## Review of NATO CALS Data Model v. 4.0

Dr. John W. Sheppard  
ARINC  
2551 Riva Road  
Annapolis, MD 21401  
jsheppar@arinc.com

In response to an action item from the 00-D meeting of the DMC, a review of the NATO CALS Data Model (NCDM), version 4.0 was performed relative to requirements emerging relative to P1522 and TMIMS. Since the action item was assigned, it was discovered that the NCDM is now referred to as the NATO Product Data Model (NPDM); however, in this document, we will continue to refer to the model as the NCDM.

**Figure 2.** Construct for Standard/Non-Standard Values

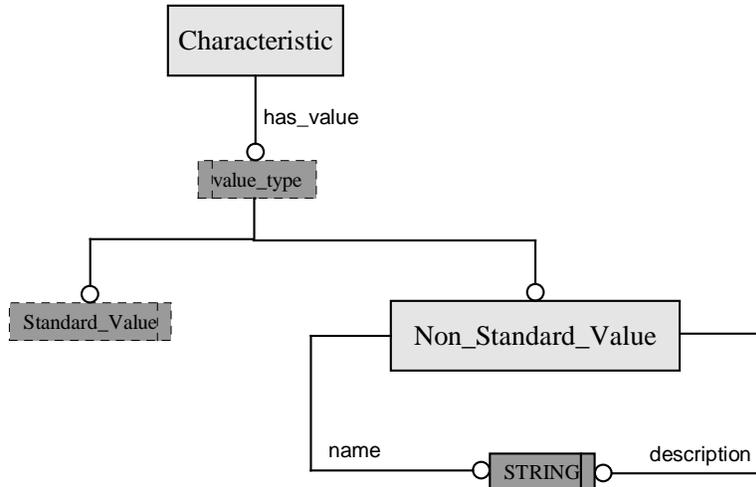
Another interesting stylistic item within the NCDM became evident from examining the Core Model. The Core Model permits specification of attributes with “standard” values and “non-standard” values. This is similar to AI-ESTATE in the way it defines standard and user-defined outcomes for tests and diagnoses, except that the NCDM approach is rather clever. The approach is illustrated in Figure 2. Specifically, the value of a given attribute is tied to a SELECT type that

selects between a standard value (defined in an enumerated type) and a non-standard value (defined as an attribute-value pair).

1. Modify the AI-ESTATE construct for handling user-defined values to parallel the structure shown in Figure 2.
2. Adapt maintenance architectures within AI-ESTATE, TMIMS, and P1522 to be consistent with the logistics activity (Core Model) and maintenance concept (Logistics Support Analysis Model) entities.

**Figure 3.** Anomaly Hierarchy

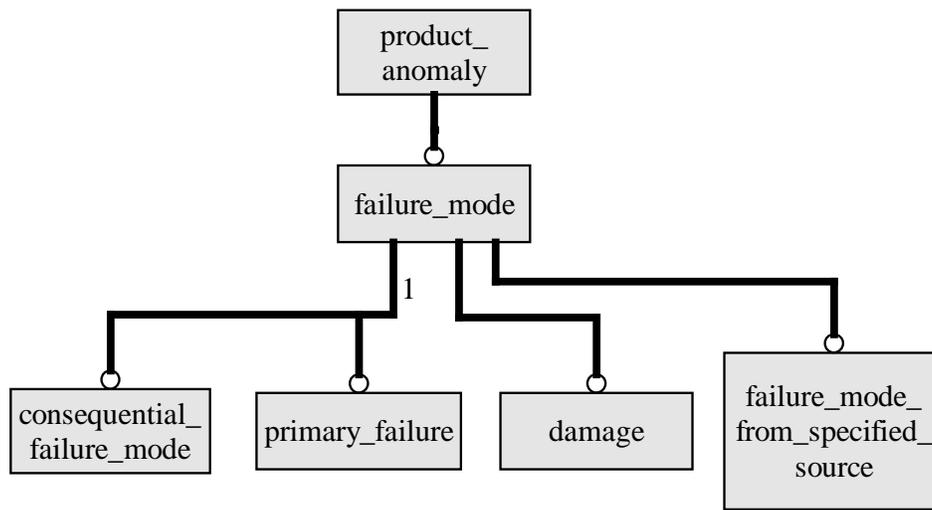
The NCDM description indicates that an anomaly can be either a failure or damage. However, the actual model shows an anomaly to be the root of a class hierarchy as shown in Figure 3. This model does not correspond to the description in that failure mode is a subtype of anomaly and damage is a subtype of failure mode.

**Figure 4.** Cause-Effect Model

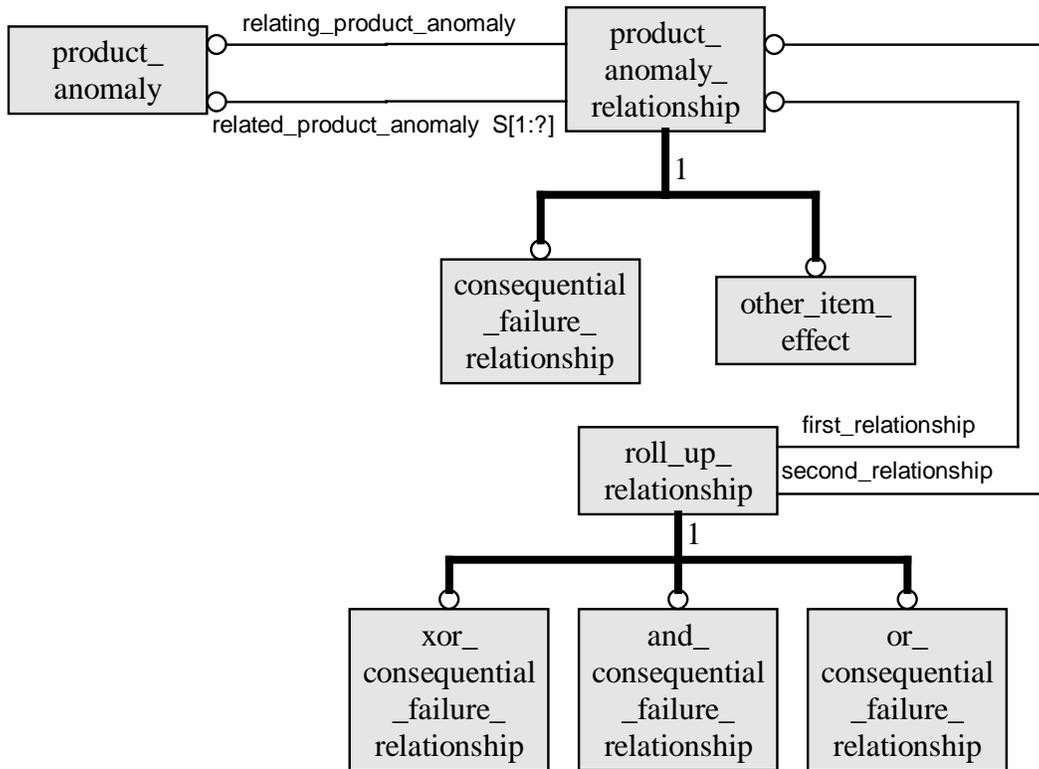
through the consequential failure relationship (NCDM §6.2.2). This is shown graphically in Figure 4. Some construct similar to this would be useful in certain kinds of diagnostics, especially when treating multiple faults; however, the implementation shown here is confusing and difficult to implement.

There is an additional confusing construct related to consequential failure relationships. Specifically, the product anomaly relationship identifies related and relating product anomalies. In addition, the consequential failure relationship, which is a subtype of the product anomaly relationship, identifies a relating anomaly. The type of the relating anomaly is consequential failure mode while the type of the relating product anomaly is product anomaly. Recall that a failure mode is a subtype of product anomaly, and consequential failure mode is a subtype of failure mode. The point of this discussion is that it is unclear how the relating product anomaly compares to the relating anomaly. The model provides no definition of relating anomaly that distinguishes it from the relating product anomaly. This indicates potential confusion and ambiguity in this part of the model.

4. Track activities within TMIMS analogous to the activity entity within the Product Configuration Model.
5. Include constructs to address cause-effect relationships between failure modes; however, do not follow the construct provided within the NCDM.

**Figure 5.** AI-ESTATE Diagnosis Submodel.

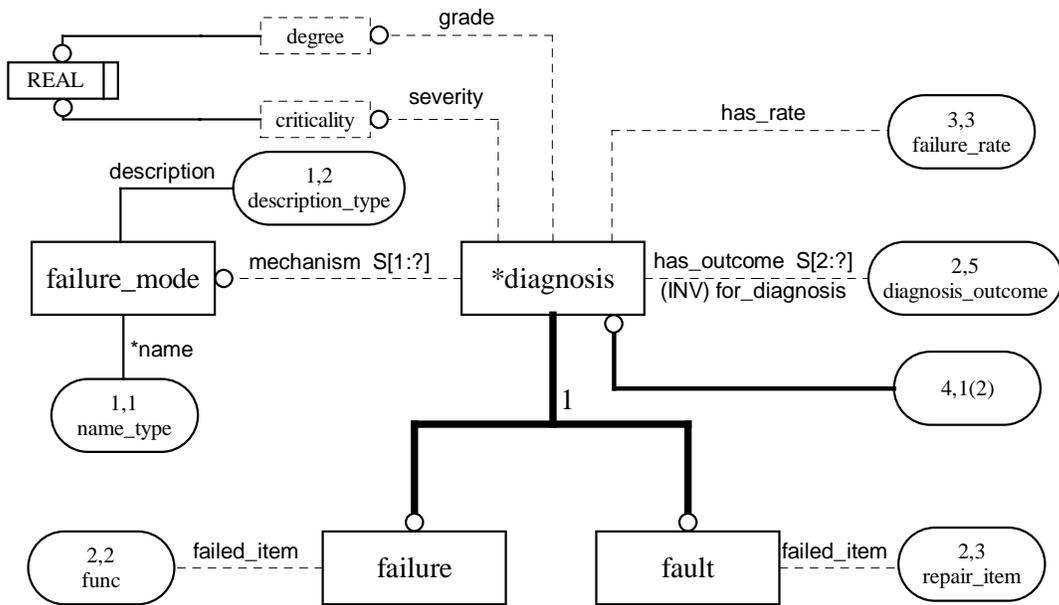
Within the AI-ESTATE model (Figure 5) is defined information relative to the severity and degree of a diagnosis (i.e., failure). Similarly, the NCDM specifies severity (within the Failure Analysis Model) and criticality (within the Task Description Model). Within AI-ESTATE, we seem to confuse these two concepts since we provide an attribute of diagnosis labeled severity with type criticality. Within the NCDM (§6.4.4), severity relates to a safety hazard and is enumerated as catastrophic, critical, marginal, minor, negligible, and none. Of course, this can be generalized beyond safety, but it is clearly intended to rate the severity of the failure mode relative to the ability to satisfy some requirement. On the other hand, criticality is intended to indicate “if failure to accomplish [a task] in accordance with system requirements would result in adverse effects on system reliability, efficiency, effectiveness, safety, or cost (NCDM §7.4.17).” Specifically, severity relates to the failure mode while criticality relates to a task. Otherwise, the two concepts appear to be virtually identical.

The AI-ESTATE model has also started to include information related to context within which a repair item is used and tested. The Failure Analysis Model includes information related to missions and mission phases that further extend the type of information captured relative to

context. The construct used, while still not sufficiently detailed, is valuable and should be added to the context information included in AI-ESTATE.

6. Parallel NCDM in definition of criticality and severity.
7. Enhance the AI-ESTATE model to include information on mission and mission phase within the context portion of both the Common Element Model and the Dynamic Context Model.
